# Staff Report

Infill Housing Design Review Committee

File Number: 11-D-21-IH

**Location:** 1506 Ohio Ave. **Parcel ID** 81 | P 008  
**Zoning:** RN-2 (Single-Family Residential Neighborhood)  
**District:** Lonsdale Infill Housing Overlay District

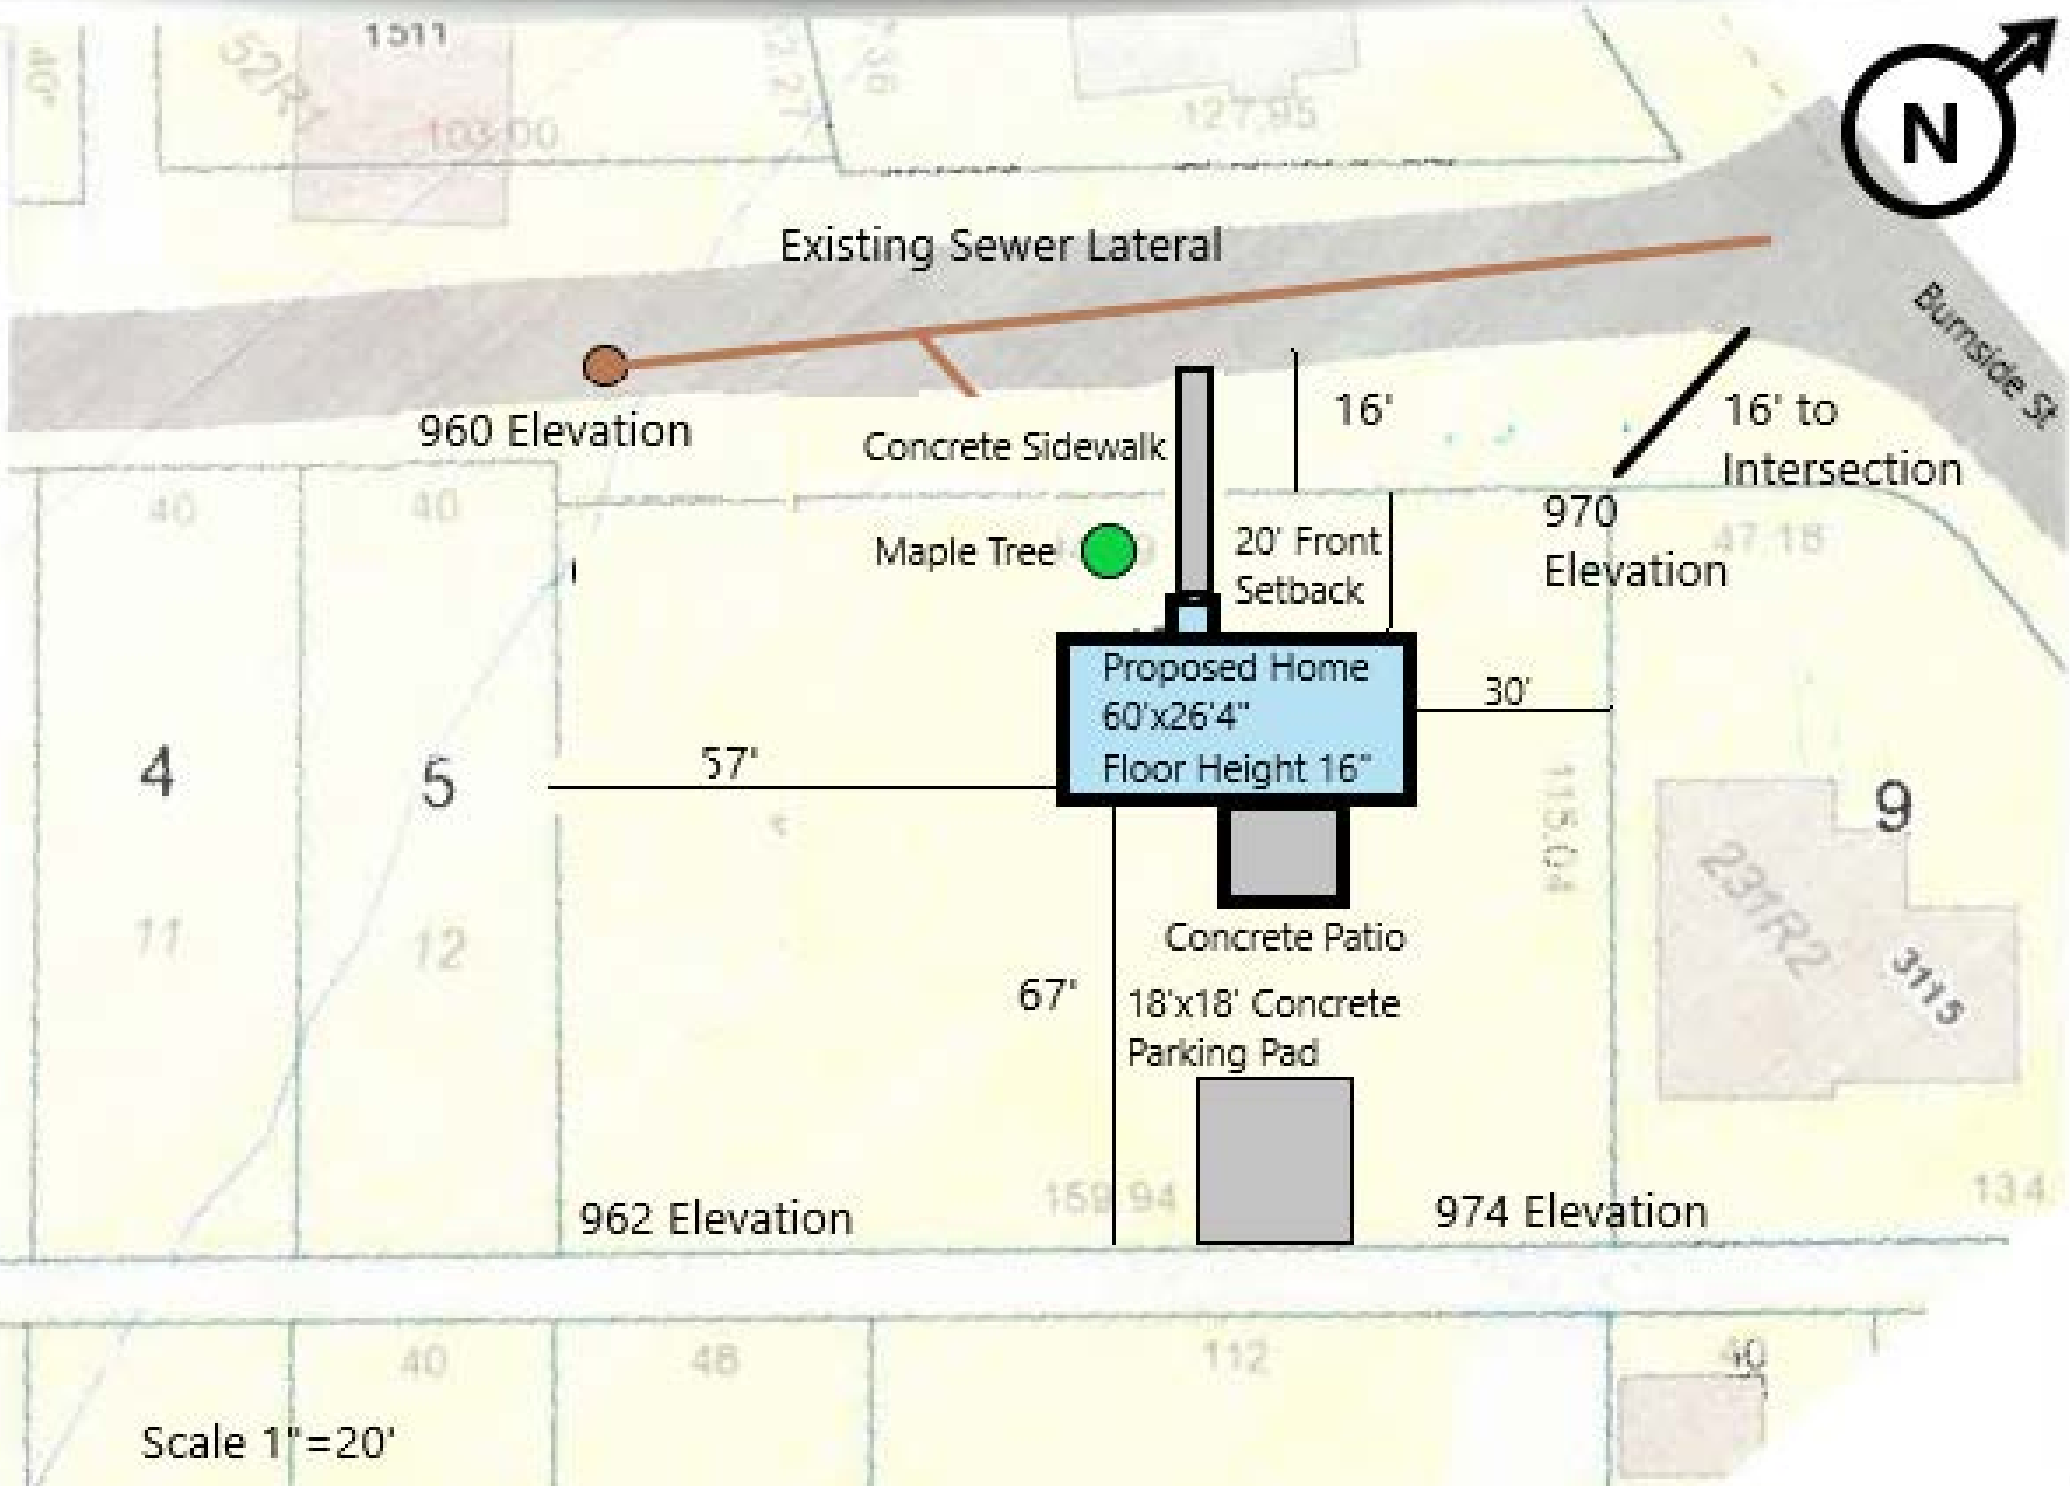
1. The house is proposed for the center/center right of a 200' wide lot. The lot is uniquely large for the context, measuring approximately 200' wide and 115' deep. The house is proposed to be set 20' from the front property

line, 57' from the left side property line, and 30' from the right side property line. The block lacks sufficient context for an average front setback. A recently-approved house at 1520 Ohio Avenue was approved to be set 20' from the front property line. The side setbacks will be wider than the typical neighborhood pattern and create an inconsistent rhythm of houses if the adjacent lots are developed. The front setback will be consistent with the other house on the block. The site plan includes a concrete walkway to the street.

3. The parking has been revised from the initial submission to be accessed from the alley. Engineering has also noted the presence of a 30' buffer zone from the top of the bank, which should be noted on the site plan, along with the distance from the buffer zone to the proposed house.

9. The site plan has been revised to incorporate one tree in the front yard.
10. The previous staff recommendation was denial without prejudice; or postponement to submit an application which more clearly meets guidelines. The items detailed in the previous staff recommendation include 1) a steeper-pitched roof (6/12 or higher) with 12" or more eave overhangs; 2) the addition of a porch, with roof, detailing, and placement to meet design guidelines; 3) the revision of parking placement to meet Infill Housing guidelines and City Engineering standards; 4) the use of lap siding instead of Dutch lap siding; 5) the use of appropriately sized window trim and a revised front door to meet guidelines.

1506 Ohio Ave, Knoxville TN 37921 Map 81 Parcel 081IP008

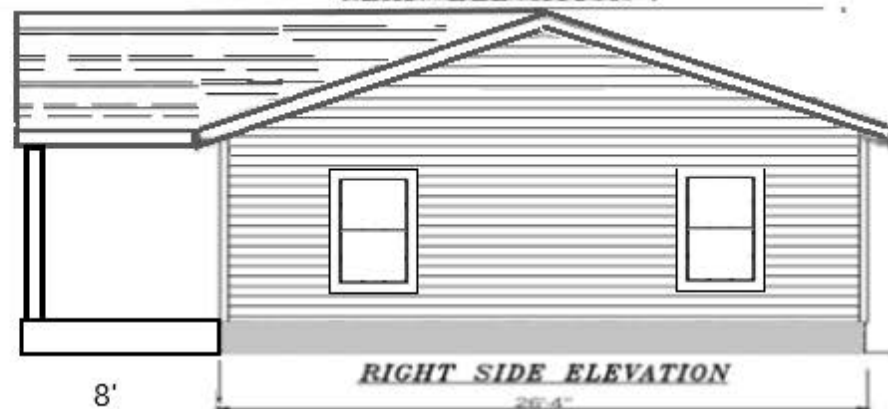
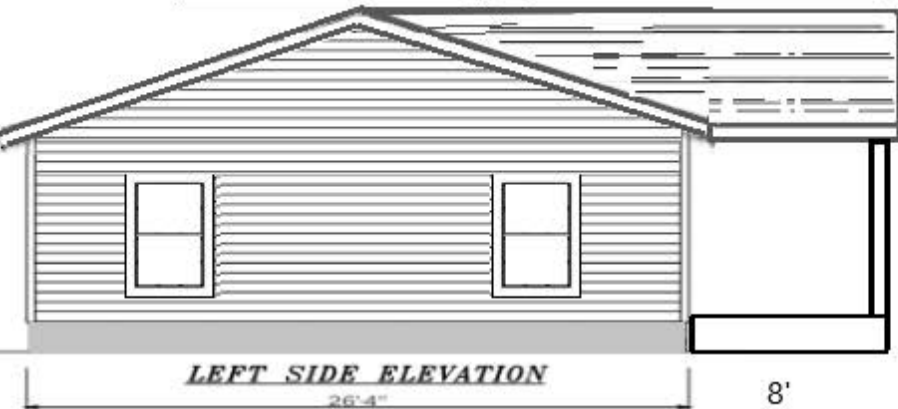
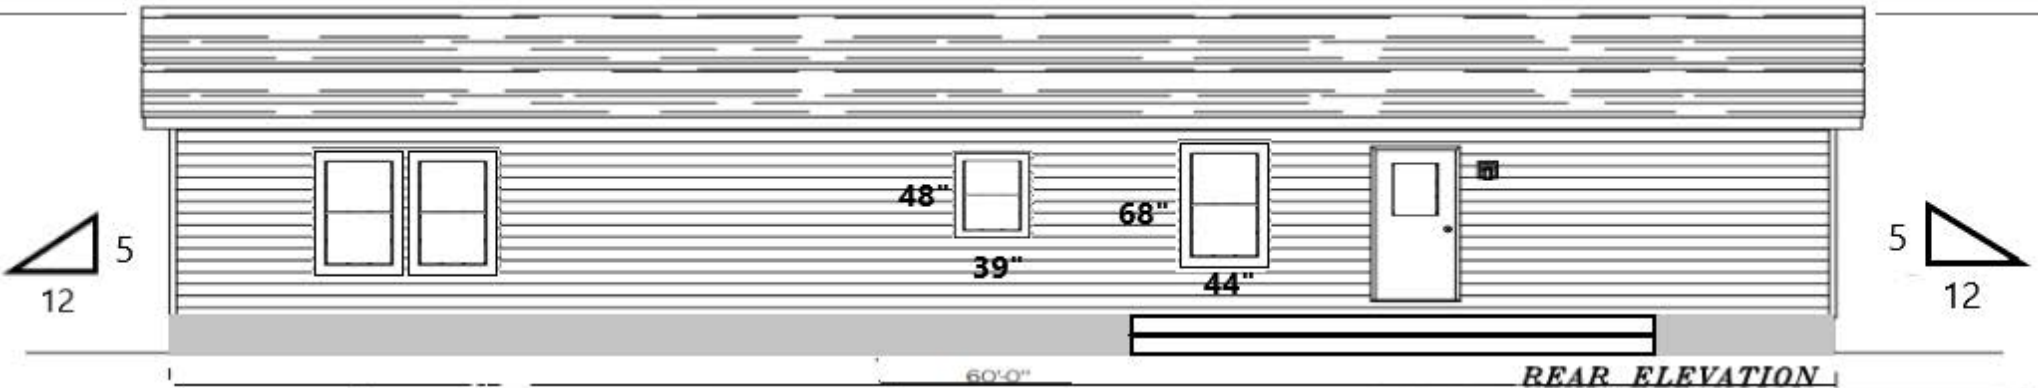
5. The house has been revised to incorporate an 8' deep by 10' wide front porch, with a 5/12 pitch front-gable roof supported by 6 by 6 columns.
6. The proposal does include sufficient transparency on the front, side, and rear elevations. The door shown in elevation drawings is not compatible with the historic context.

7. The house has been revised to incorporate a 5/12 pitch roof. The minimum pitch approved by the board has generally been 6/12. The house incorporates no additional roofline complexity other than the added front porch roof.

8. The proposed vinyl siding, stuccoed foundation, and asphalt shingle roof does meet the design guidelines; however, the vinyl Dutch lap siding is discouraged in Infill Housing reviews. Lap siding with an overlap to resemble wood clapboard siding would be more appropriate.
